**PALM BEACH COUNTY
SOLID WASTE AUTHORITY**

Re: Response to July 17, 1985 Letter
Application for Power Plant Siting Certification
Resource Recovery Facility
Palm Beach County Solid Waste Authority

RESPONSE TO FLORIDA DEPARTMENT OF ENVIRONMENTAL REGULATION

Letter Dated July 17, 1985

Figure 4.2-1

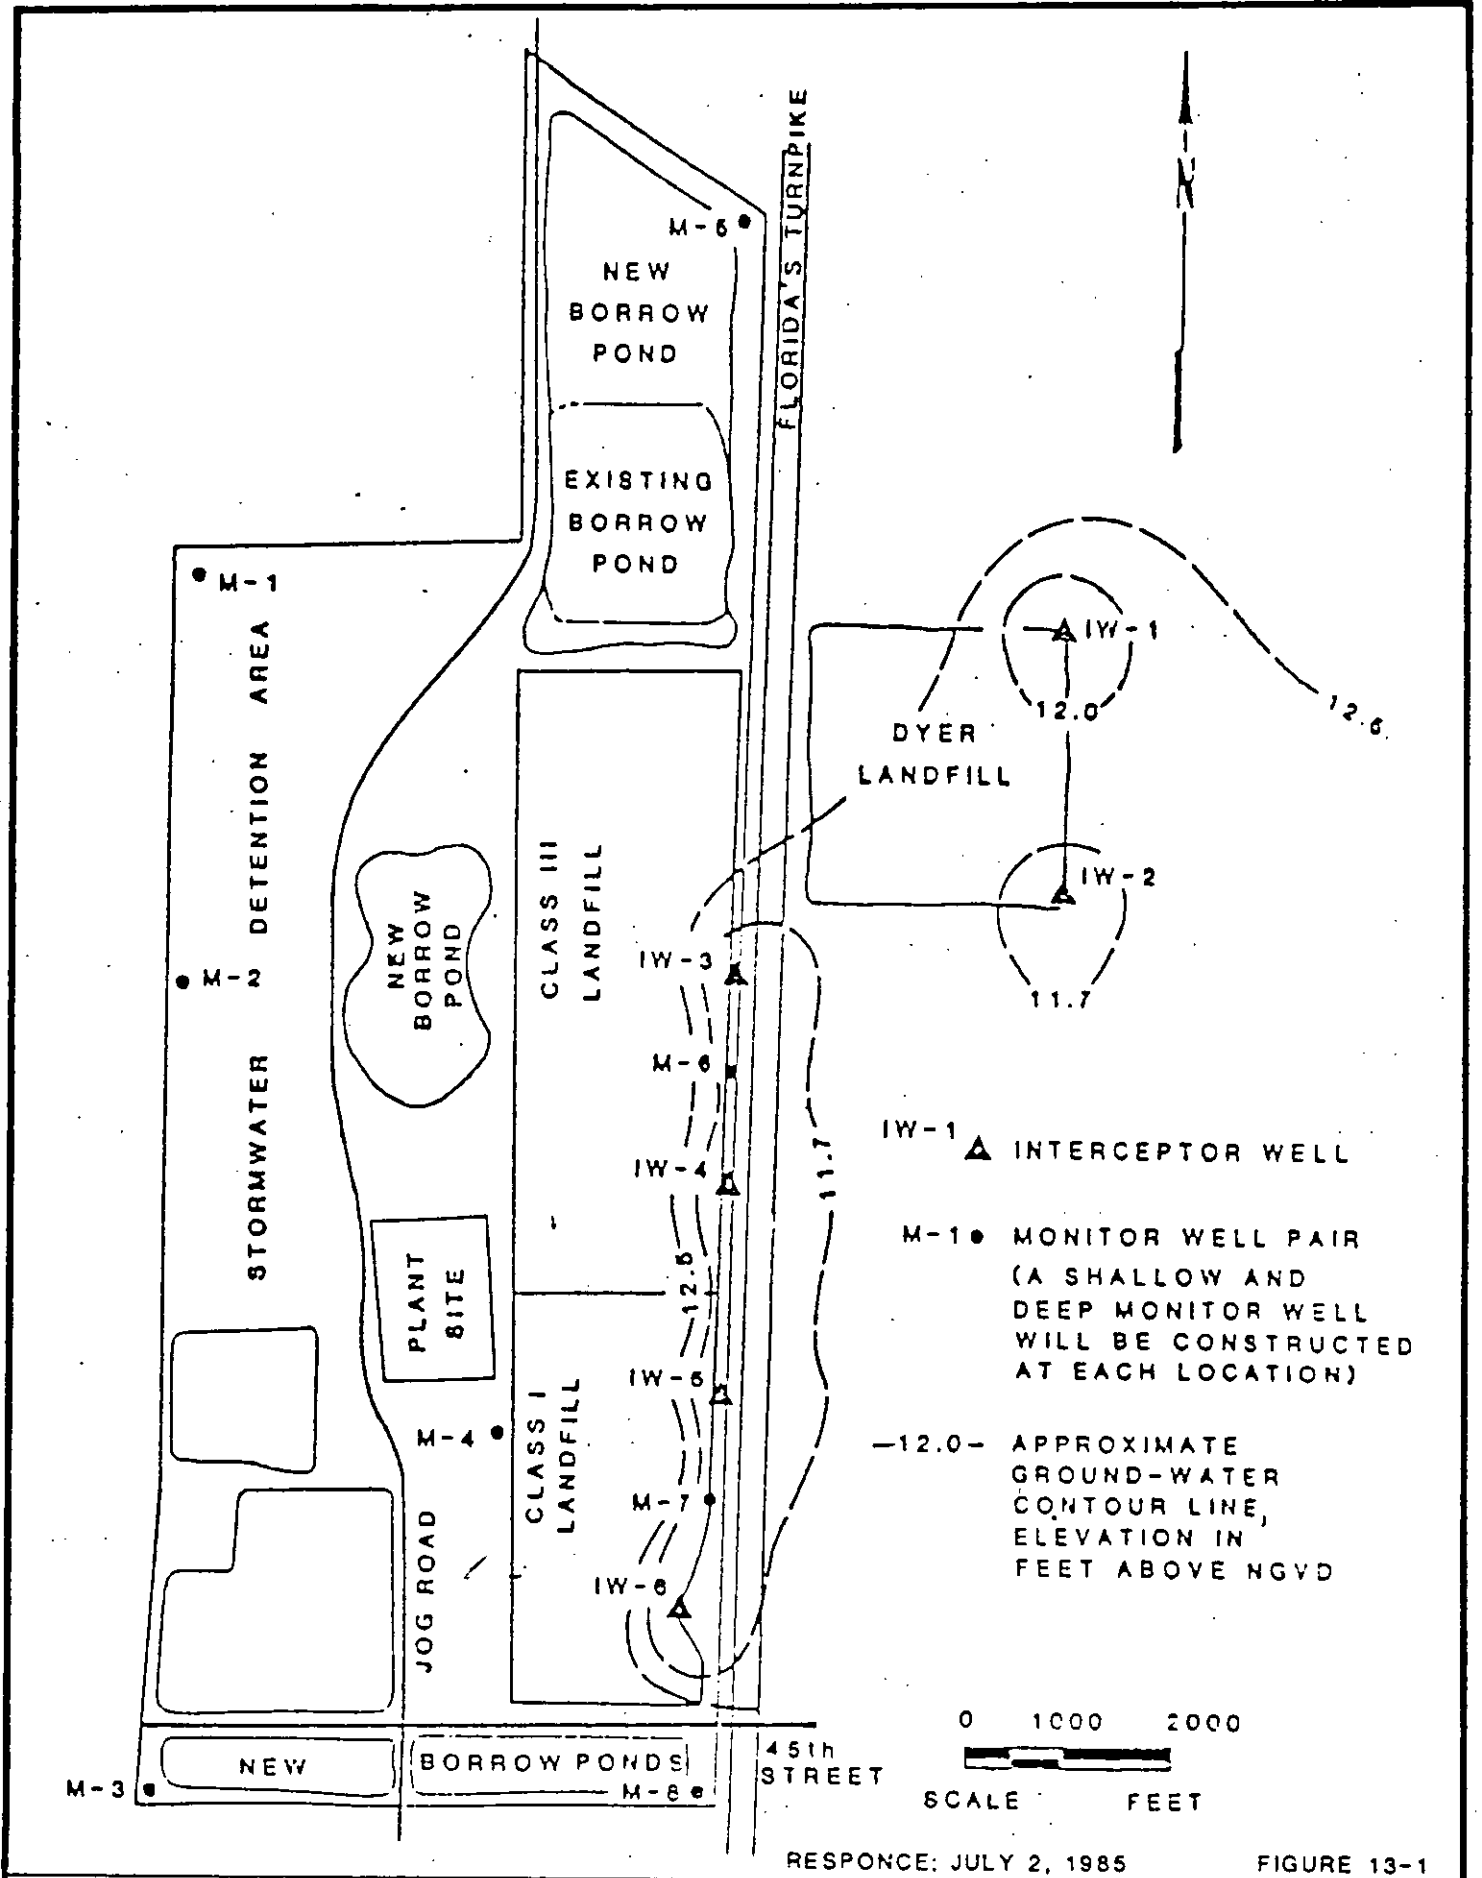
ITEM 4: Monitoring well no. 10 (shallow) appears to be located between the landfill access road and the liner near proposed Phase IV of the Class I area. As its location seems prone to much activity, what measure will be taken to protect this well?

RESPONSE: Monitoring well no. 10 is approximately 10 ft. west of contour elevation 30 as depicted on the submitted plans Sheet 15 of 25. Monitoring well no. 10 is a shallow monitoring well and may be utilized during the operation of the landfill. It is anticipated that the well will be extended to a top casing at elevation 17 so that a seasonal high water table will not effect the well. During construction of the landfill and in the vicinity of well no. 10, a corrugated metal pipe will be placed vertically around the well casing at a reasonable distance above ground. This procedure will insure that construction equipment, vehicles, and activities do not jeopardize the integrity of the well. Once construction is finished in the vicinity of well no. 10, a field crew will inspect the well to insure proper operation.

planned structures; otherwise, they will be properly abandoned. The proposed monitor wells will be constructed at locations shown on Figure 4.2-1 (Figure 13-1, Response to July 2, 1985 Letter). The ground water monitoring program, including a discussion of the proposed monitor wells, is described in Chapter 4, Section 4.2.2.1.

FIGURE 13-1

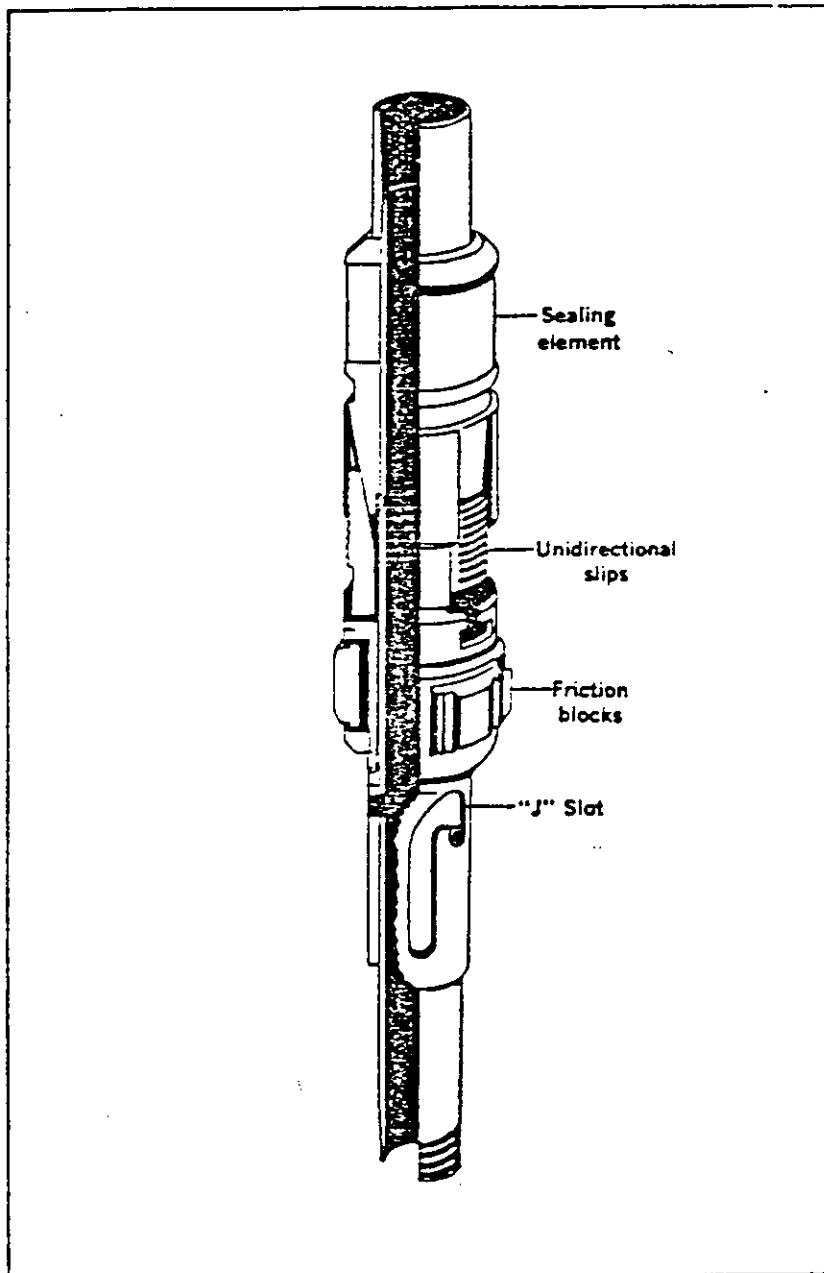
ITEM 3: Details of the packer assembly should be provided (preferably a drawing).

SWA RESPONSE NO. 13: A schematic drawing of a typical packer assembly has been included as Figure 13-1.

INJECTION WELL DESIGN
AND DETAILS OF THE CORING
AND TESTING PROGRAM

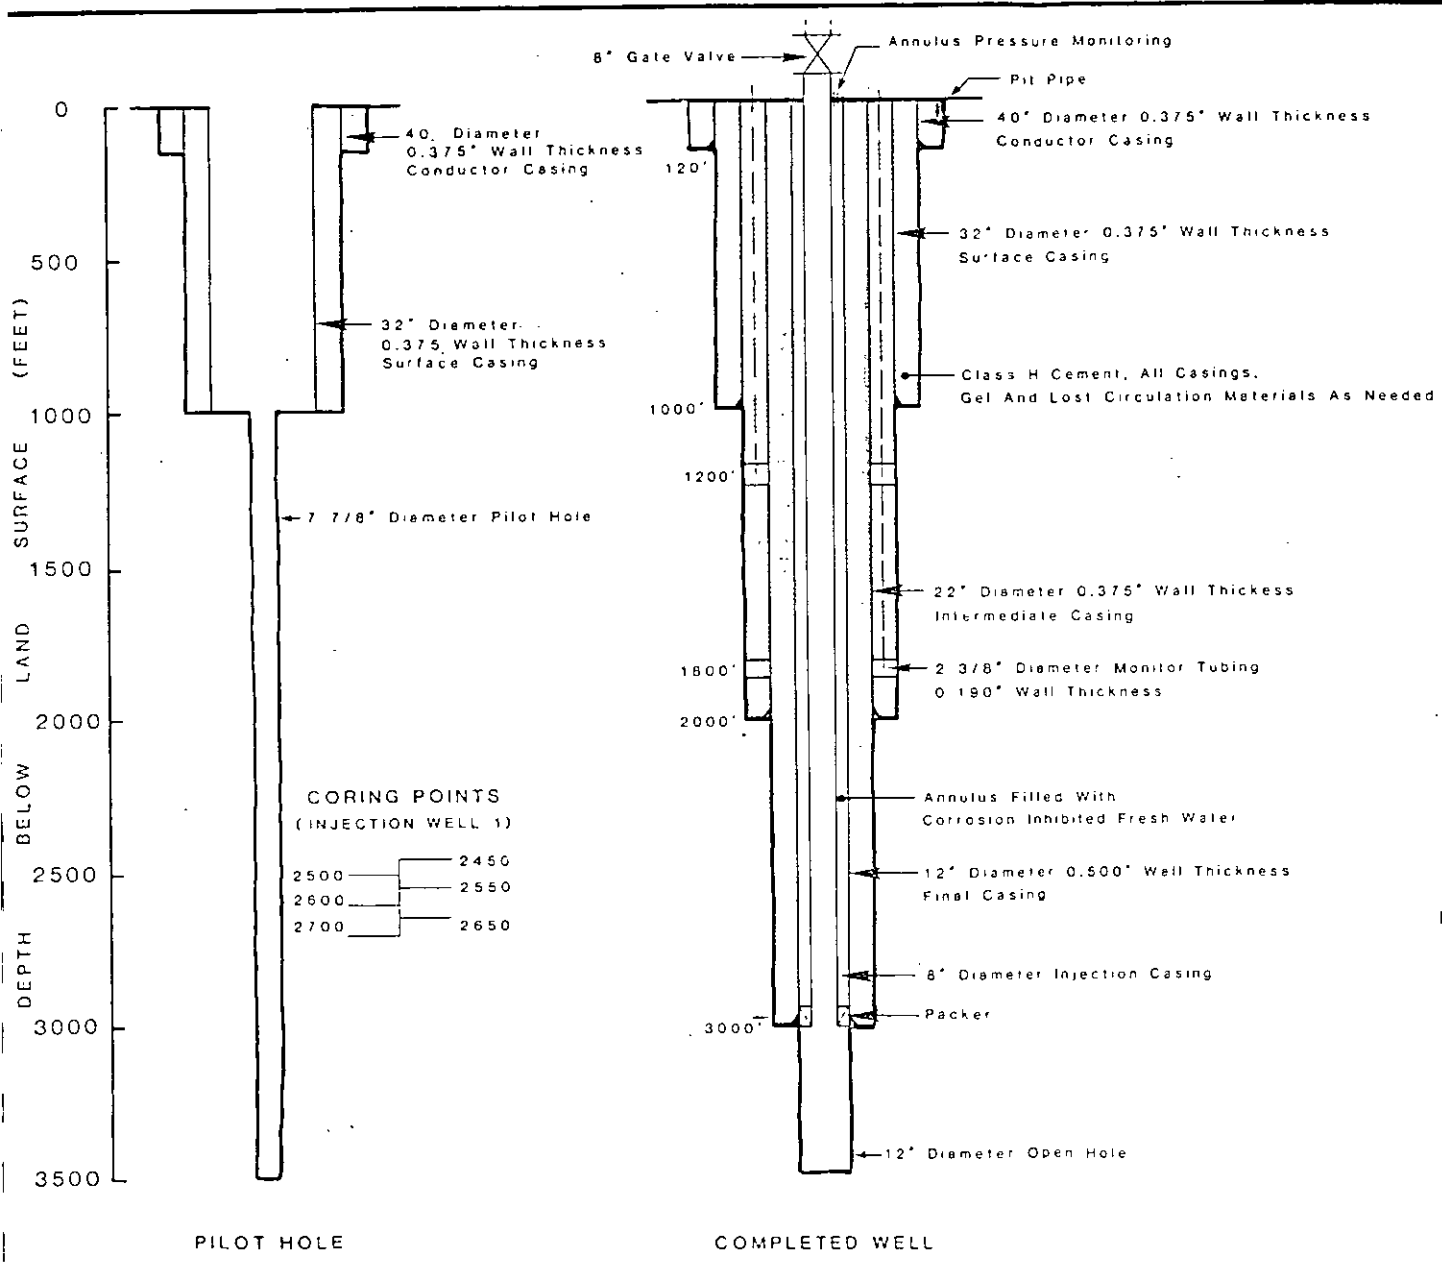
ITEM 6: Specify whether the proposed monitor well will monitor waters containing greater or less than 10,000 mg/l TDS. Why is no monitoring of the upper Floridan aquifer proposed? This is a deviation from the current practice in the area.

SWA RESPONSE NO. 16: The upper monitor tube, included in the Specifications, will be set at approximately 1,200 ft. and used to monitor the upper Floridan aquifer. The upper monitor tube is shown on the accompanying Figure 16-1. The lower monitor tube will be set below waters containing less than 10,000 mg/l TDS.

RESOURCE RECOVERY PLANT
SITE PLAN

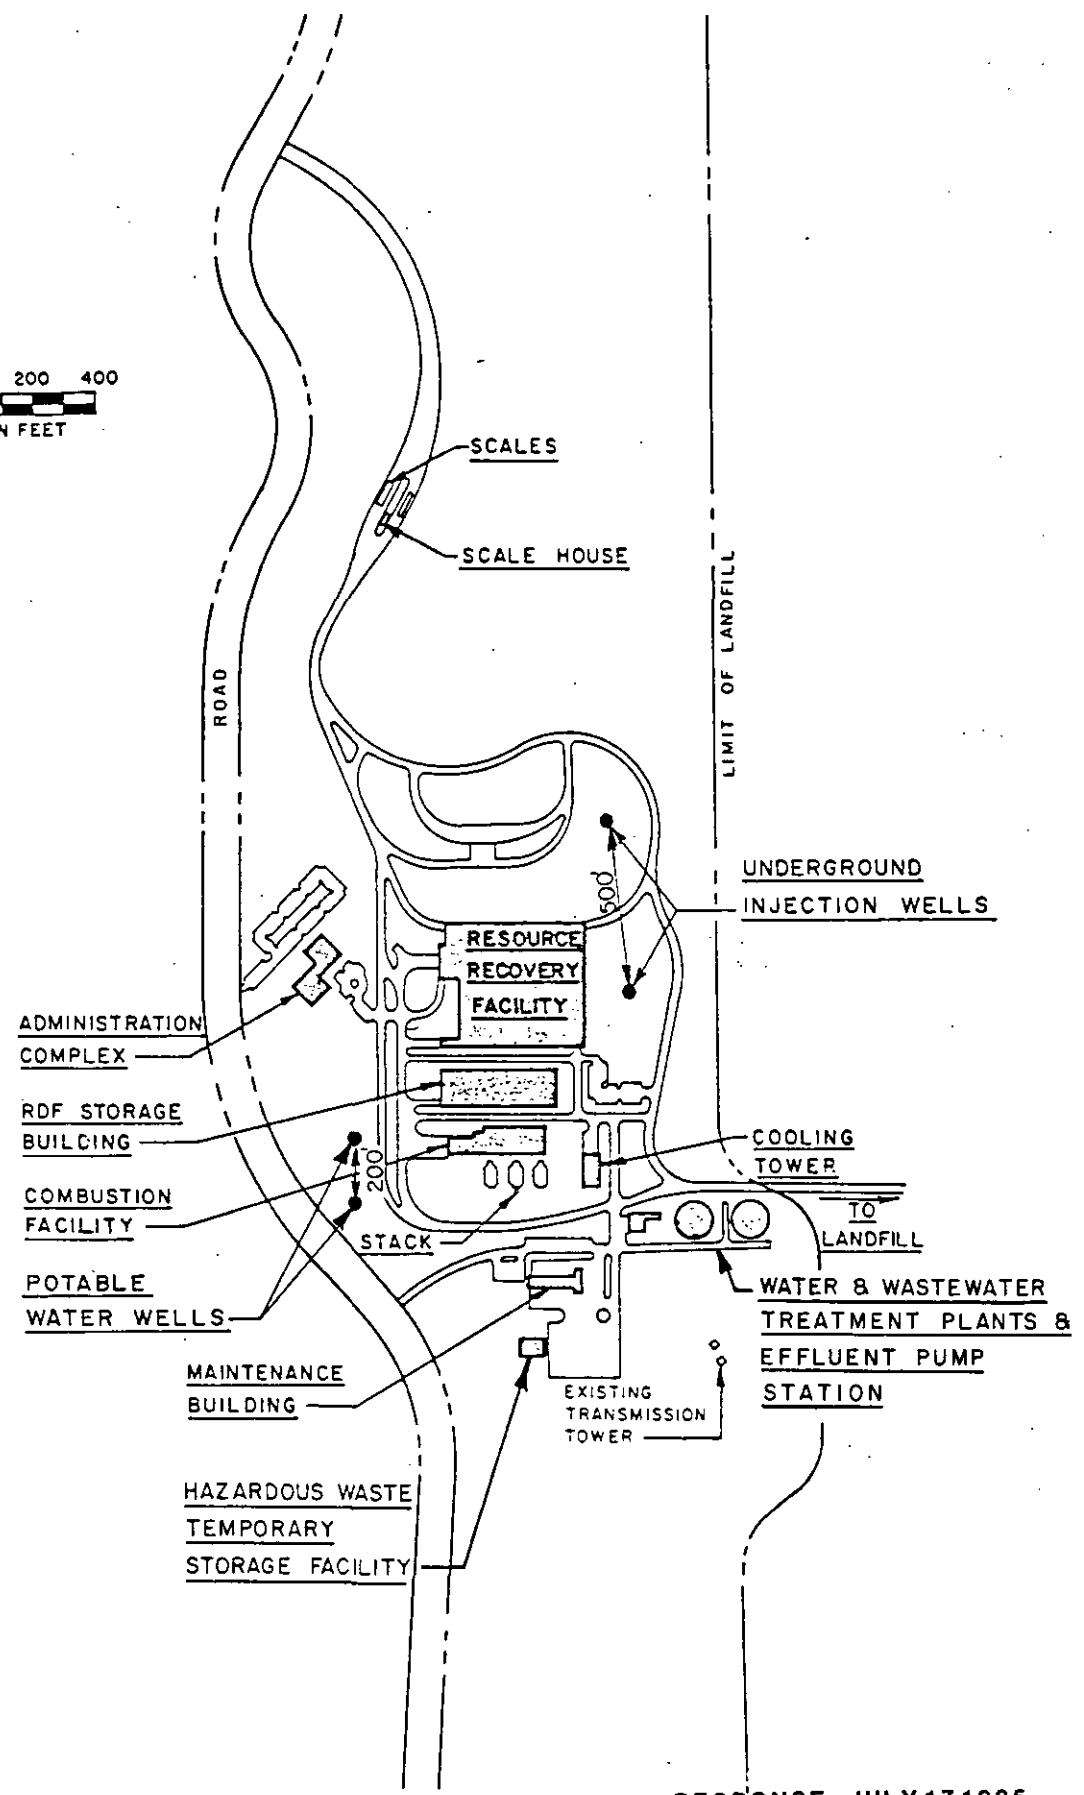
ITEM 9: A site drawing showing the proposed location of the injection wells is required. At a minimum, this drawing should indicate the distance between the wells.

SWA RESPONSE NO. 19: The location of the deep wells are shown on the accompanying Figure 19-1, Response to July 2, 1985 Letter. The separation distance between wells will be approximately 500 ft.

COMPLETED WELL

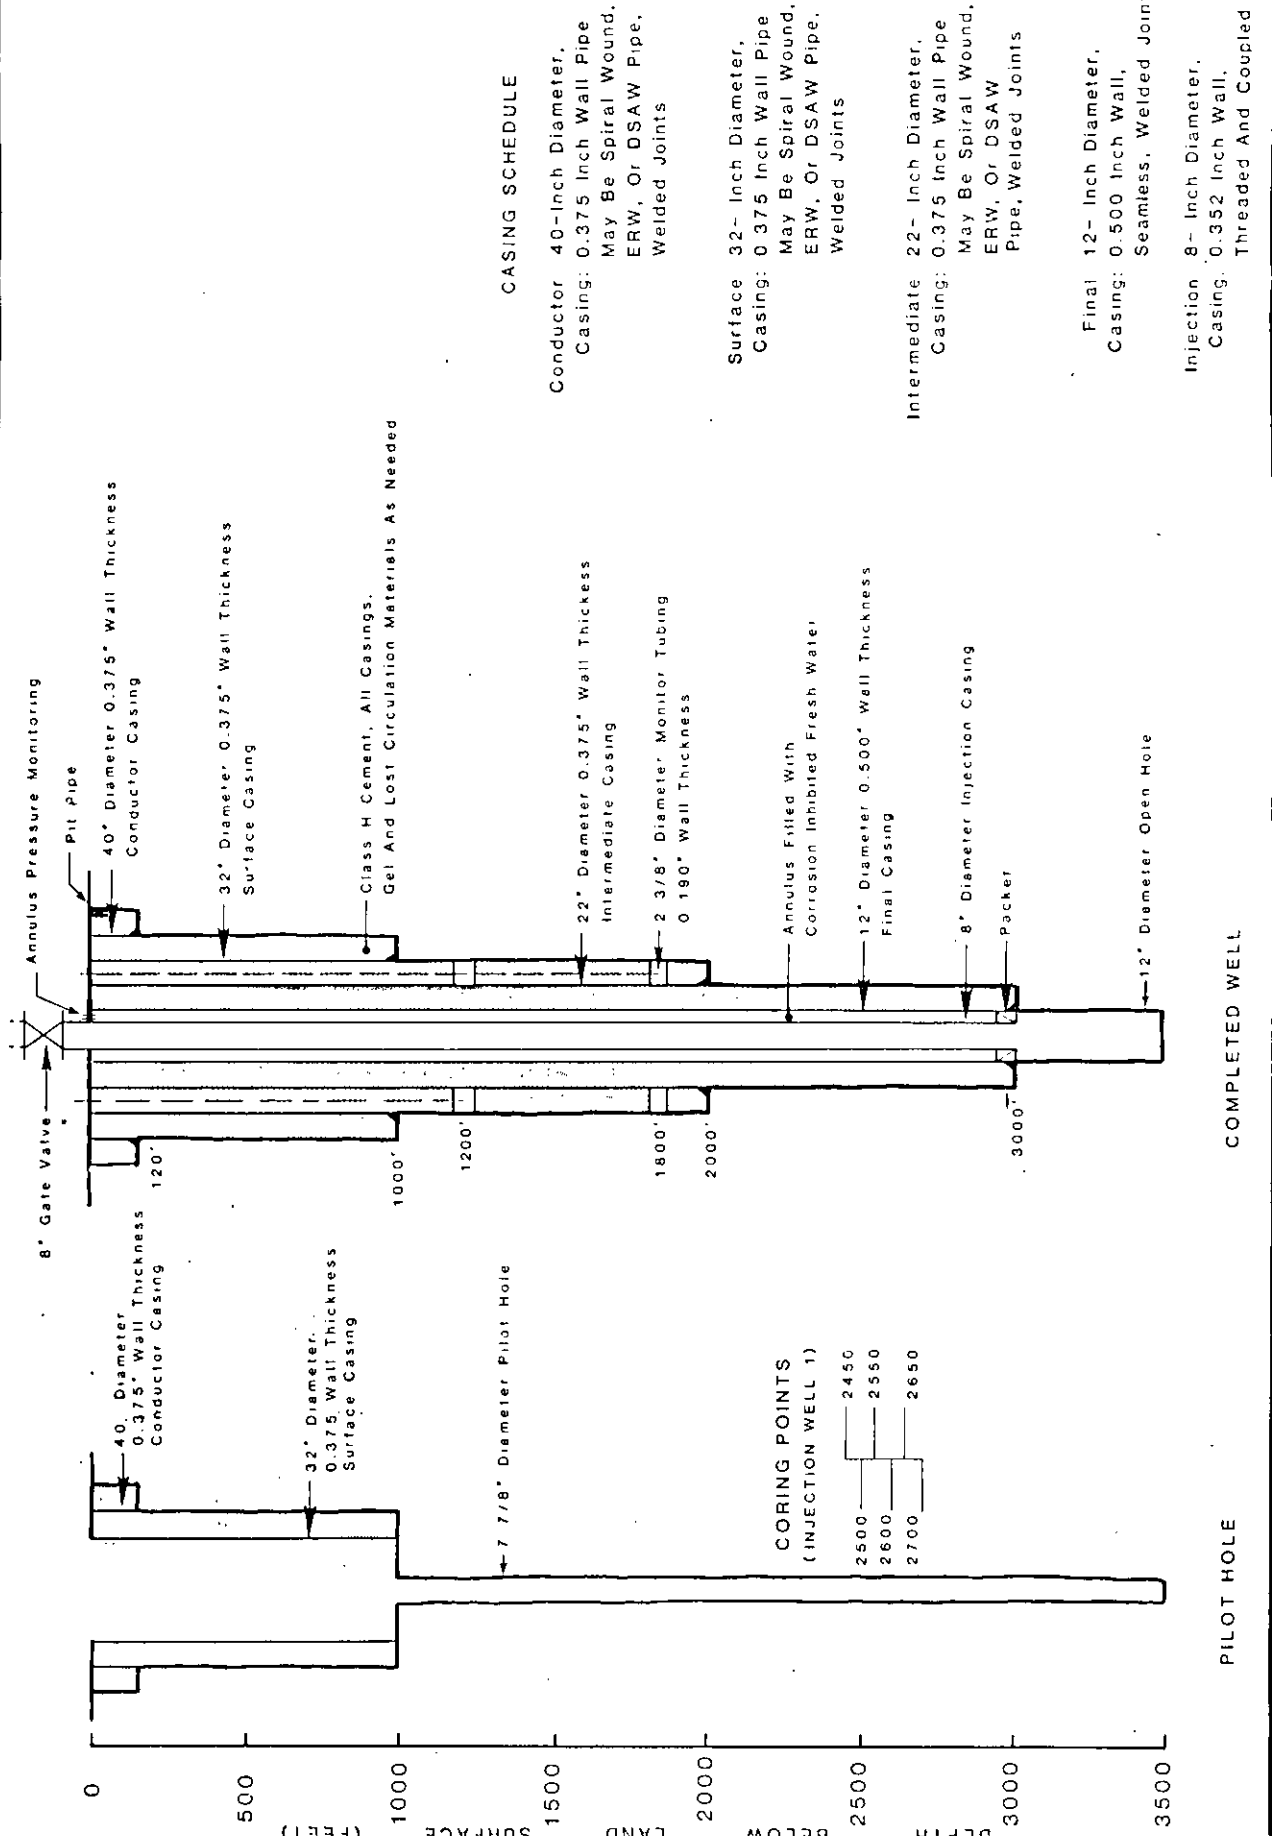
ITEM 11: Figure 5 (Appendix 10.8) shows the final casing string (12 inch) as being ERW pipe with a wall thickness of 0.500 inch. The Construction and Testing Program and Technical Specifications texts indicate this casing string will be seamless pipe with a 0.500 inch wall thickness. Which is it? Any deviation from seamless pipe with a 0.500 inch wall thickness must be justified in writing (Rule 17-28.(4)(b), FAC).

SWA RESPONSE NO. 21: Figure 21-1 has been corrected and included to show that the injection casing will be 0.500 in. (wall thickness) seamless casing as specified in the Program and Specifications.
